ADDENDUM NO. 2

CATTARAUGUS COUNTY
LITTLE VALLEY COUNTY CENTER
ELEVATOR IMPROVEMENTS

SEPTEMBER 23, 2022

Project No. 307670

DRAWING NO. A151
SPEC _____
SECTION _____

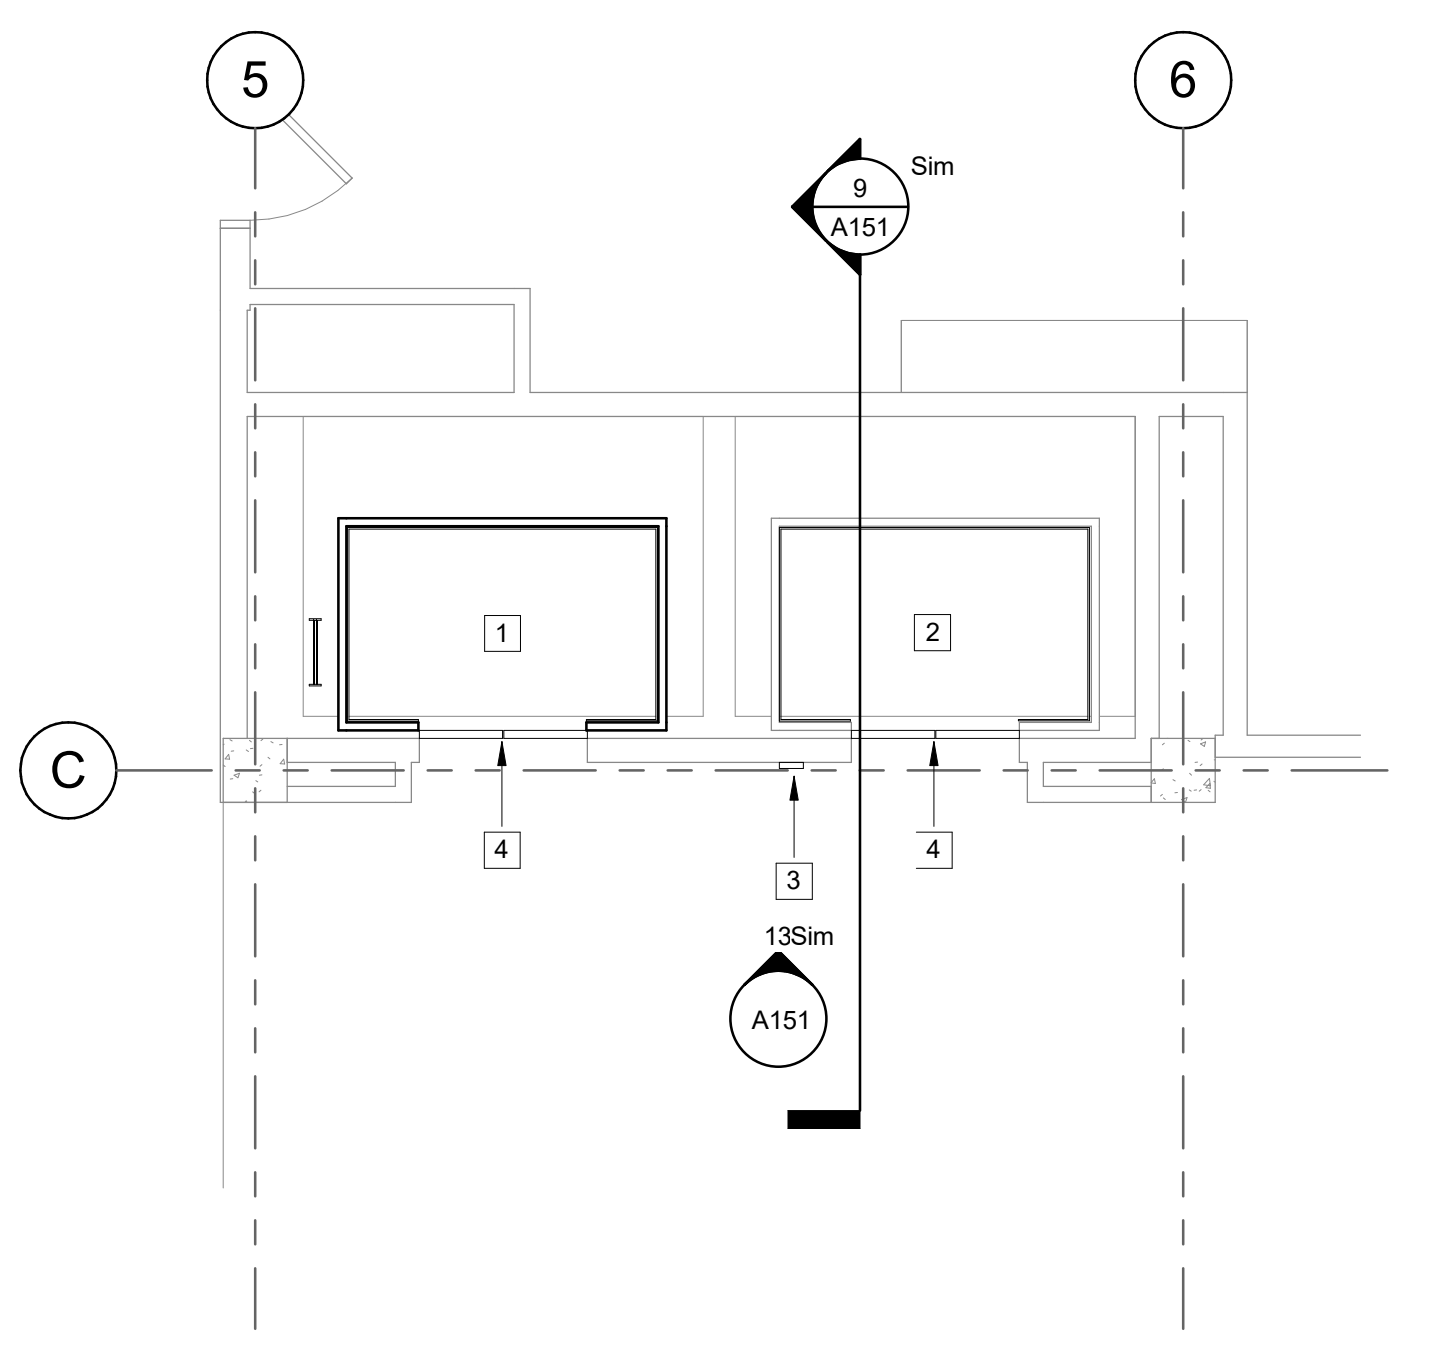
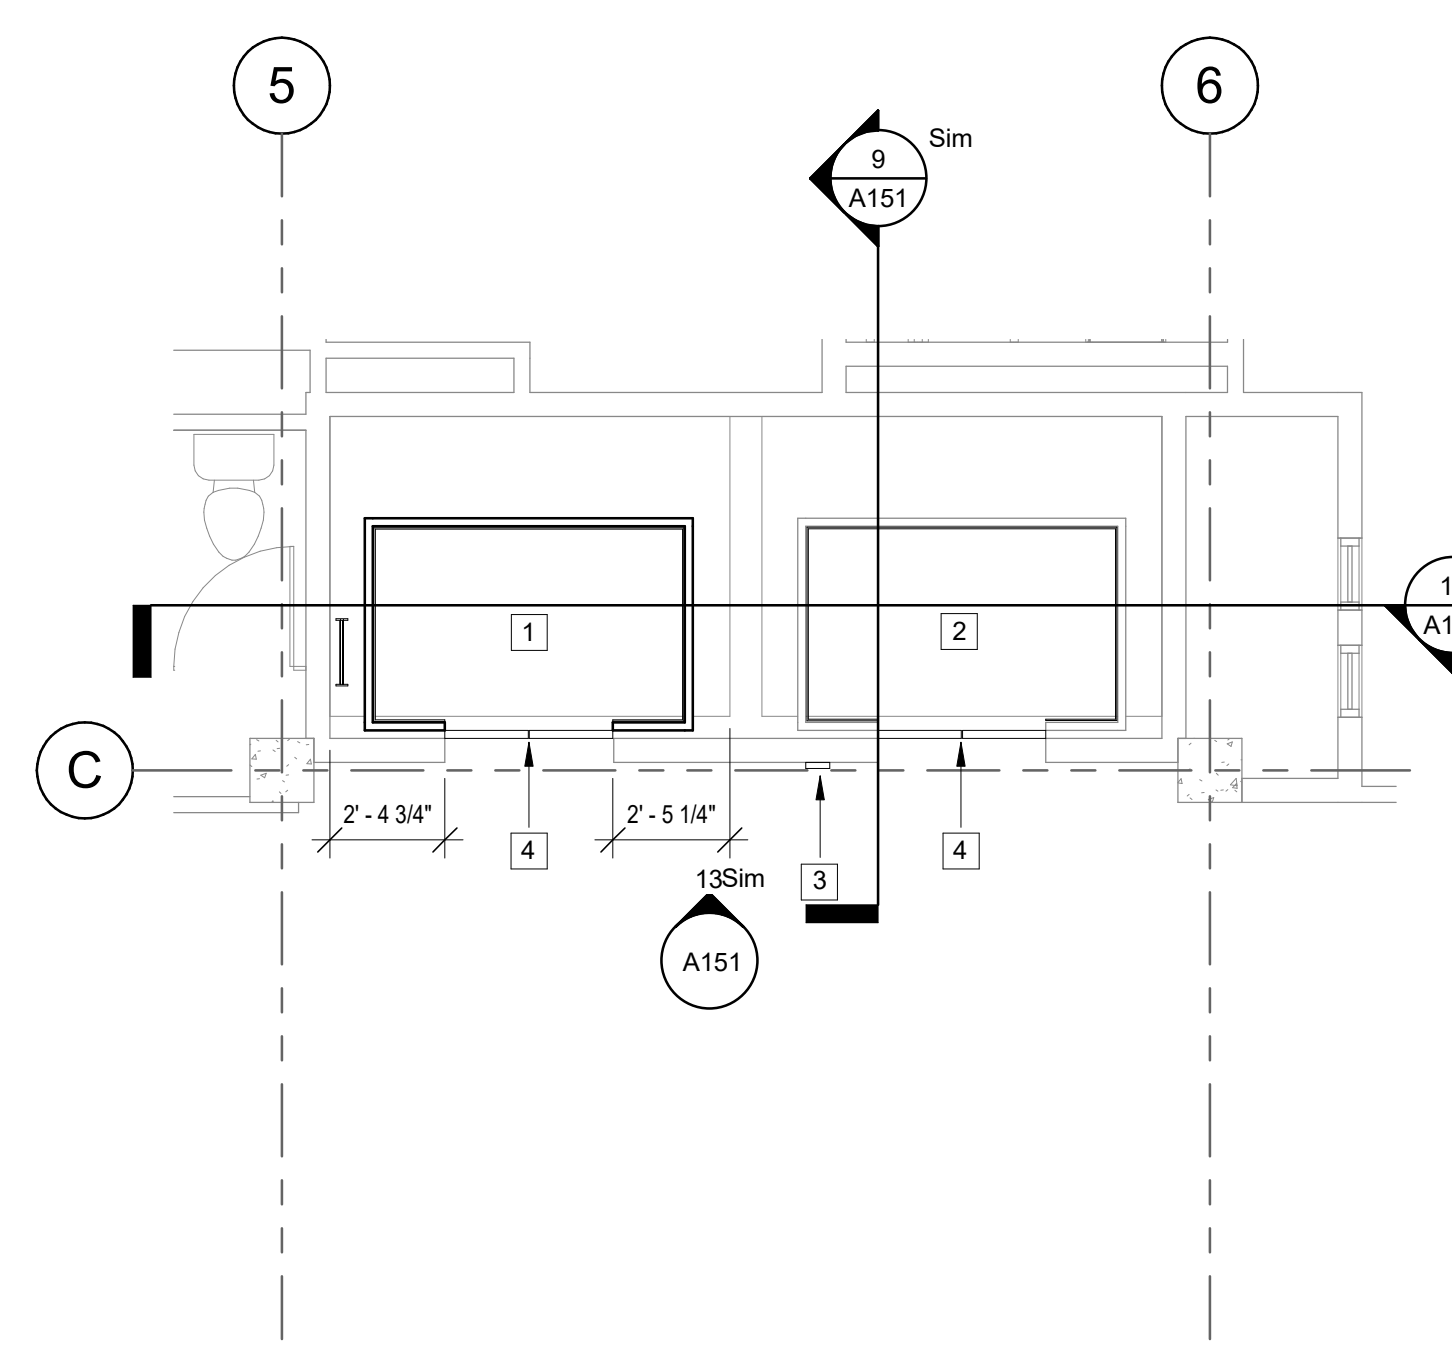
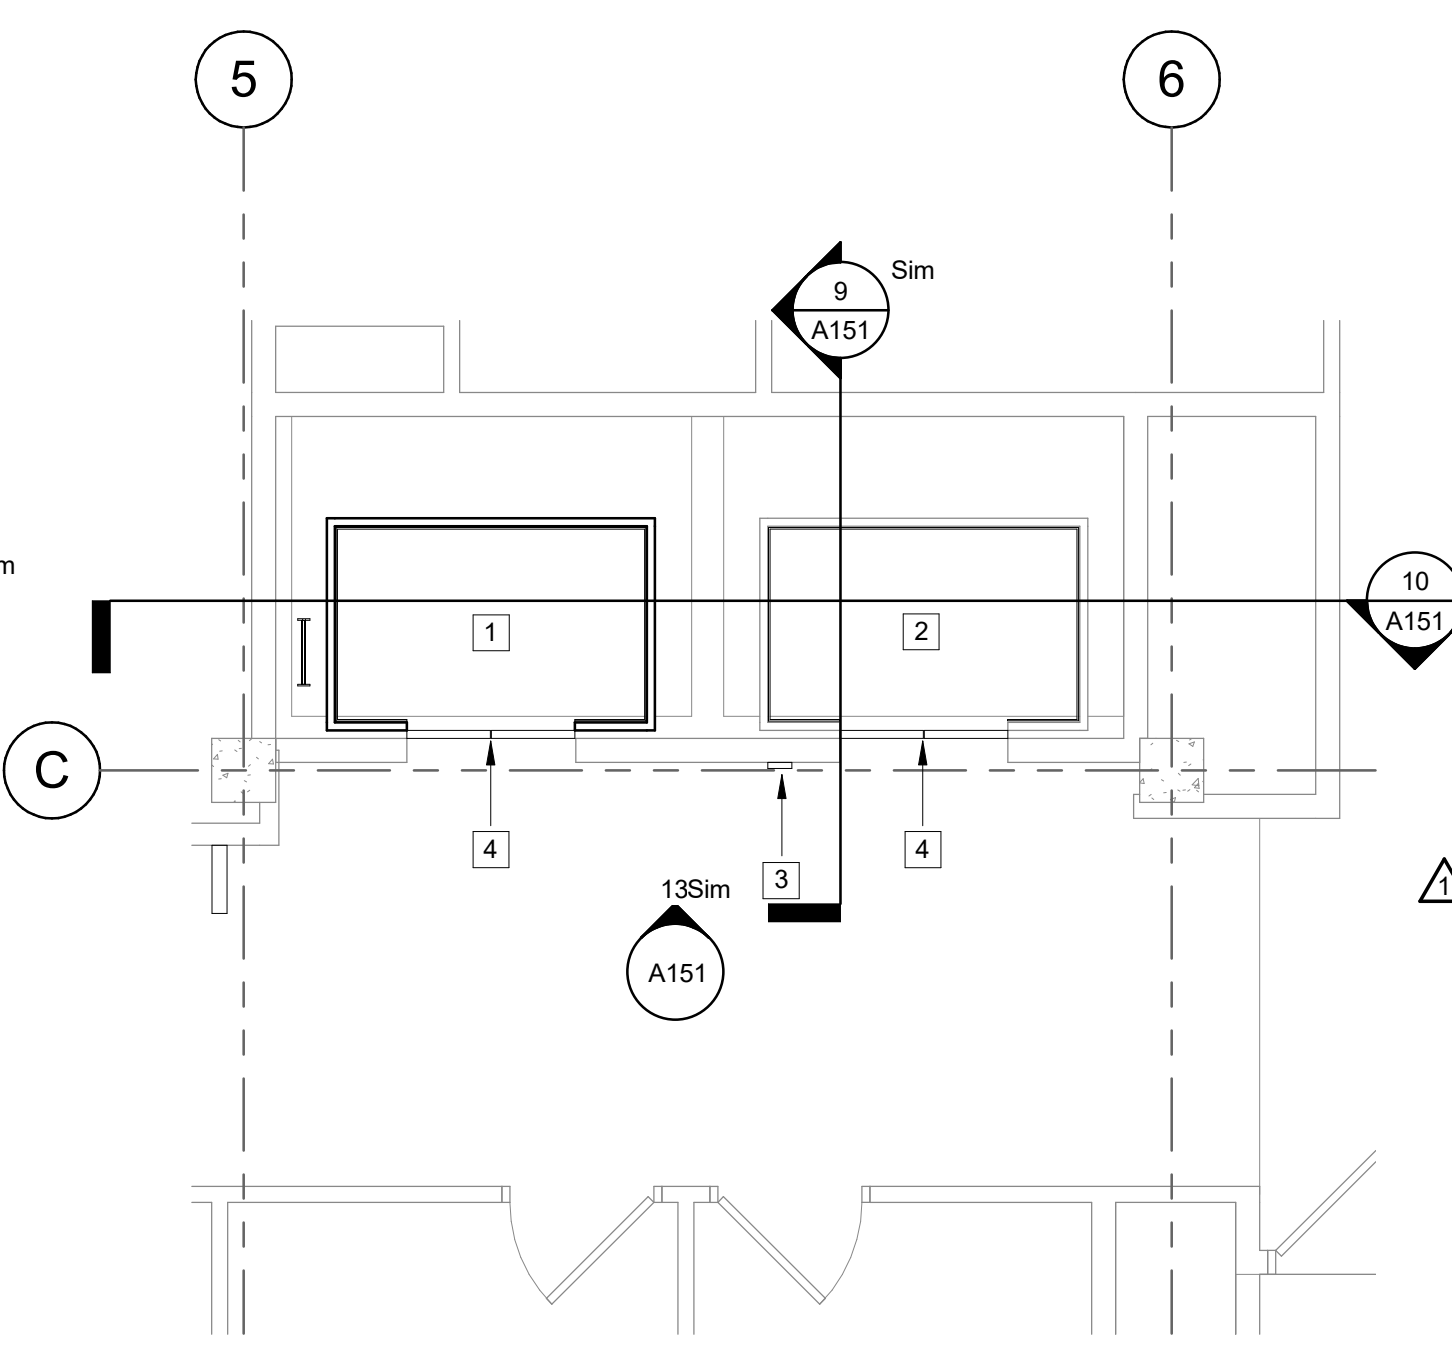
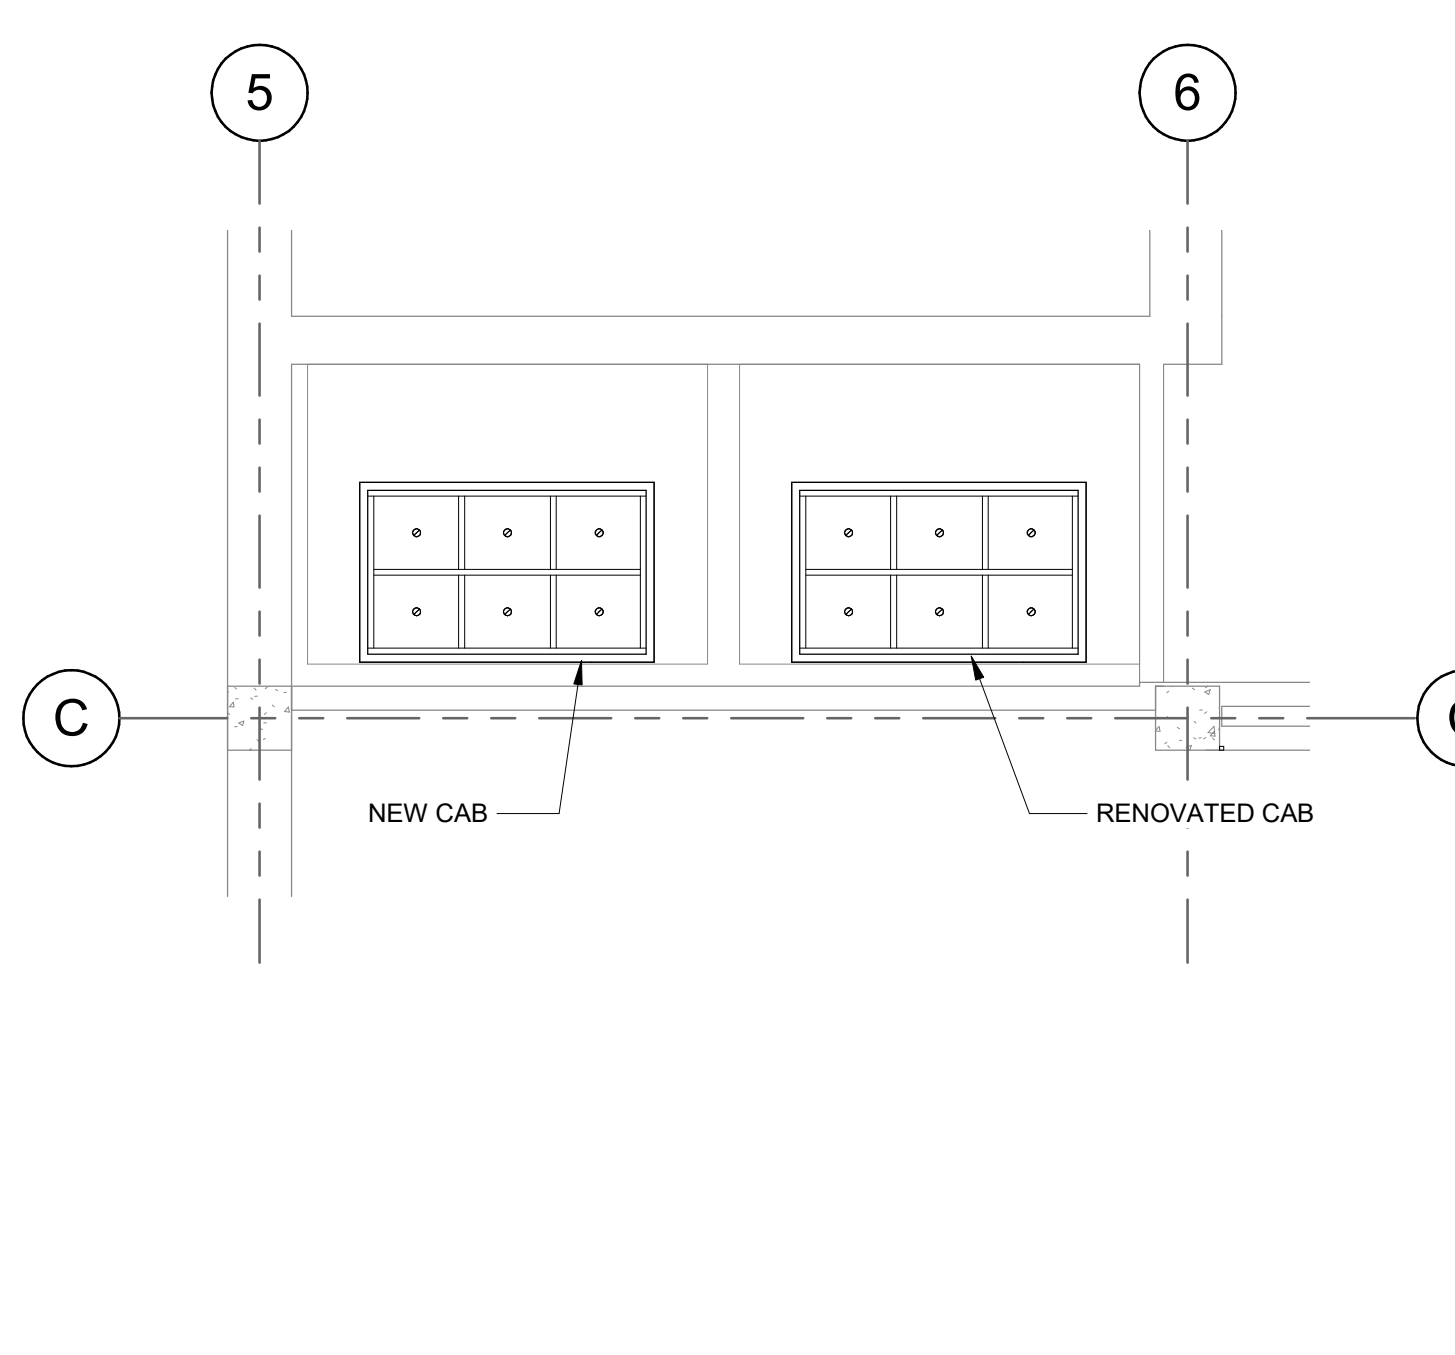
DELETE: Architectural drawing sheet A151.

ADD: Architectural drawing sheet A151 attached as part of this addendum.

- h. All new wiring, traveling cables and hardware
 - i. Inclusion of a \$25,000 per car cab allowance. **(Elevator cab finish selections are to be upgraded to match new elevator PE2 as identified on drawing sheet A151.)**
